From: Ryan Bray
Sent: 7/12/2022 9:17:46 PM
To: Council Northernbeaches Mailbox
Subject: TRIMMED: Fwd: Objection to DA at 11 Taylor St, North Curl Curl - DA2022/0798
Attachments: Submission to DA at 11 Taylor St - Ryan Bray - 07.12.2022.pdf;

**RE: 11 Taylor Street, North Curl Curl
DA2022/0798
Submission for Objection to Application**

Figure 1: Indicative photo overlay provided with applicant's resubmitted plans by 'Scope Architects' (Registered Architect Xu Kha)

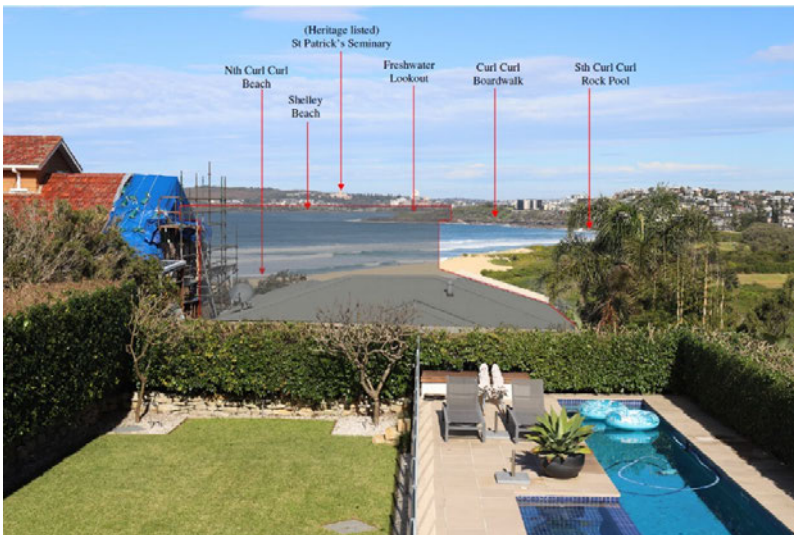
- The photo used is from the top floor – where views would be impacted the least, and also from bedrooms which are not the primary living space as outlined in Tenacity

- The submitted purple overlay is ‘indicative’ only and provides no logic to how this was generated
- Professional certified photomontages of view impacts were commissioned by neighbours at their own expense, as no attempt was made by the applicant to show consideration

- The submitted photo overlay does not match the actual impacts, when compared to the professionally certified photomontage by R.A.Walls Construction.
- The applicant's provided photo overlay is significantly misleading, and is not a reliable or accurate source, as it has not been certified or shown a methodology for its accuracy
